DATE: January 10, 2023 Item #5A  
TO: Historic and Cultural Preservation Committee  
FROM: Isabel Castellano, Historic Preservation Specialist &  
Greg Powell, Principal Planner  
Andrew Trippel, AICP, Planning Manager  
SUBJECT: Hotel Weaver project Study Session to solicit Historic and Cultural Preservation Committee (HCPC) feedback on Historic Site Plan and Architectural Review (HSPAR) submitted by EKN Development for the development of a 93-room hotel at 2 Petaluma Boulevard South, APN: 008-063-008, 008-063-009, and 009-063-11; City Record No. PLSR-2022-0017.

It is recommended that the Historic and Cultural Preservation Committee (HCPC) consider the project information and provide non-binding comments for the Hotel Weaver project, a 93-room new hotel development with associated site improvement proposed on a vacant lot within the Historic Commercial District at 2 Petaluma Boulevard South.

**Figure 15: Rooftop Floor Plan.**

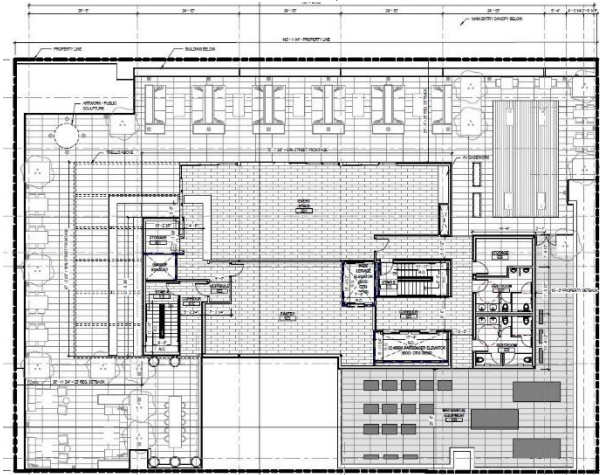
*The architectural drawings indicate that mechanical equipment is proposed on the North-*

*East corner of the sixth floor/rooftop with metal louvered panel in a bronze finish. The district guidelines recommend the equipment is screened with a solid building material. However, due to the height of the building, a light-louvered material reduces some of the overall massing. It is recommended the louvers are designed at an appropriate width demonstrating the mechanical equipment is not visible.*
